Determination 2020/022

Regarding the compliance of the foundations to a new dwelling with Building Code Clause B1 Structure with respect to the protection of other property at 48C Foyle Street, Ohakune

Figure 1: Site plan sketch (not to scale)

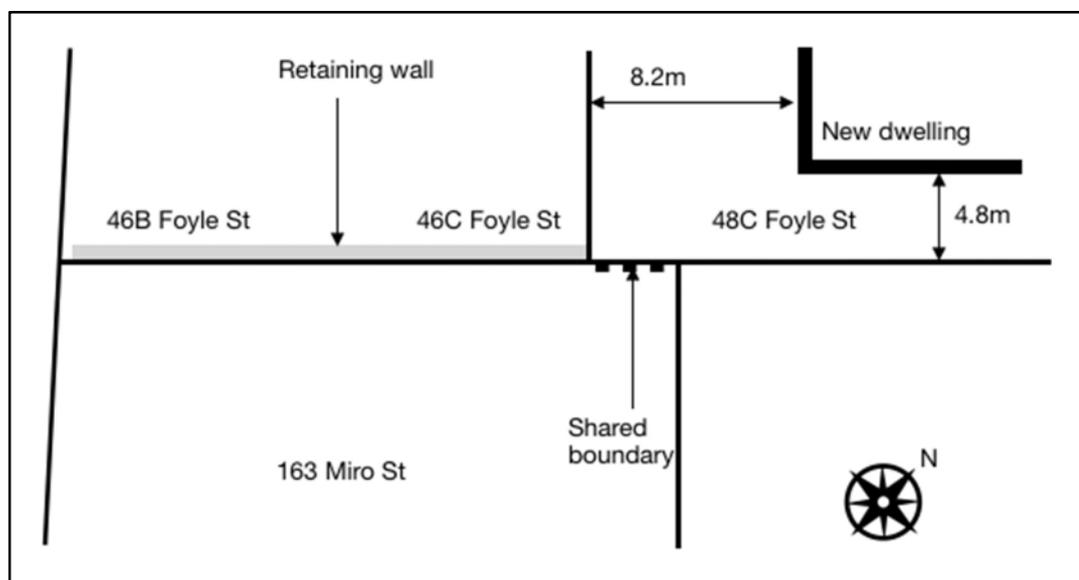
- 2.4 The new dwelling is located 4.8m from the south east boundary of the owner's property, and 8.2m from the south west boundary. The new dwelling is 9.4m from the retaining wall at its closest point. The approximate location of the new dwelling is shown in Figure 1.

- 2.7 The near flat building platform for the new dwelling slopes steeply down to the south east. The sloped ground comprises some fill over natural ground. The dwelling is located adjacent the top of the slope – the north-eastern wall of the dwelling runs along the slope's edge. The toe of the slope at its southern-most point adjoins the applicants' property along the 3.3m shared boundary.

- 2.8 At the southern end of the new dwelling, at the closest approach to the applicants' property, is a store room behind the attached carport. The ground slopes steeply to the south east at this location.
